RIVERDALE CITY PLANNING COMMISSION AGENDA
CIVIC CENTER - 4600 S. WEBER RIVER DR.
TUESDAY – MAY 23, 2023

1.
 - a. Consideration of Conditional Use Permit request for Automobile Sales and Service use by Tesla Riverdale, located at approximately 4851 South 1500 West, Riverdale, Utah 84405, as requested by 6S Development, LLC and AWA Engineering.

Final Site Plan Review: Tesla Riverdale, 4851 South 1500 West

Plan Review For Tesla

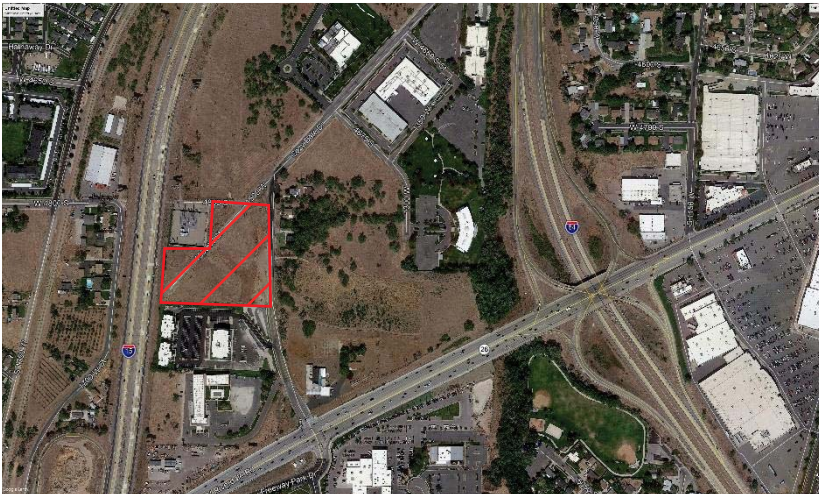
Comment: Depending on the layout, handicap ramps may be required for public sidewalk along 1500 West and 4800 South entrances to Tesla

Response: ADA sidewalk has been added along west boundary extending to 4800 South. ADA ramps have been added to allow pedestrian access across north ingress to the sidewalk along 4800 South.
